Project Martha notified resource consent applications – Requests for further information

With regard to landuse consent LUSE-202.2018.00000857.001 lodged by OceanaGold NZ Ltd for the proposed Project Martha and subdivision consent SUBD-201.2018.00000857.001 – Bulltown and Cambridge Roads, Waihi, the following further information is requested pursuant to s92 of the Resource Management Act 1991 (RMA) to enable an appropriate understanding of the proposal and assessment of its effects. Please provide this information within 15 working days (before 13 July). If you are unable to meet that timeframe please contact me so that an alternative can be mutually agreed. Under section 88C RMA the processing of the applications is suspended until the information has been received and assessed for completeness, or the 15 working day time frame has expired.

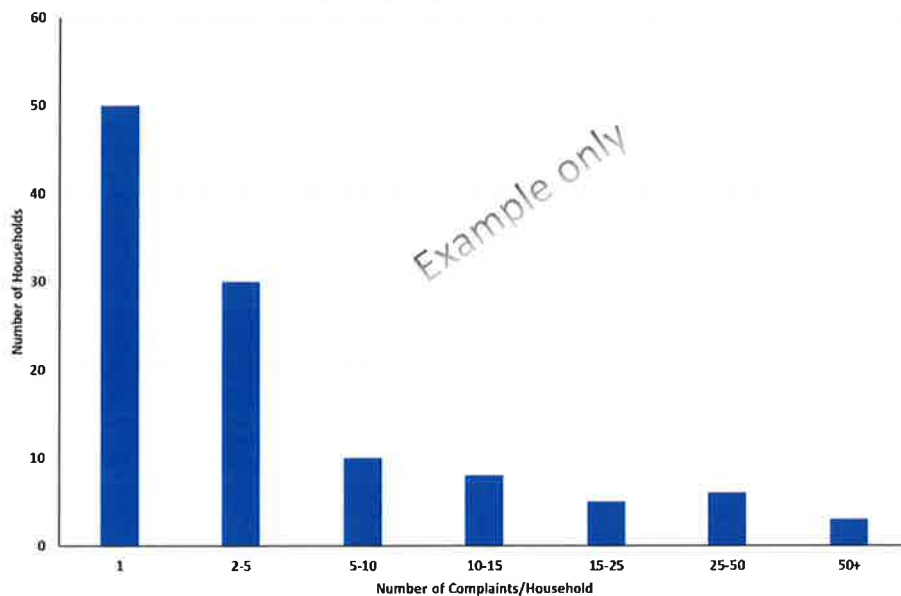
1. **Further analysis of complaints** (cumulated across issues) covering the distribution of complainant households by number complaints laid relative to the Correnso operation. This will assist the Council to determine the penetration of nuisance issues and identify whether some form of response is justified. It will also contribute to an understanding of the catchment definitions Telfer Young have adopted to assess impacts for project Martha (Above, Fringe, Outer; pages 24 and 25) relative to the zones identified for Correnso (page 3, Appendix E).

This analysis could cover both Martha Underground and Correnso Underground mines, illustrated as follows (with purely hypothetical numbers):

This could be accompanied by a map of the distribution of complaints relative to the operations and as shares of households in the vicinity. Any households recording 5 or more complaints might also be analysed by years of ownership or occupancy at the time of complaint.
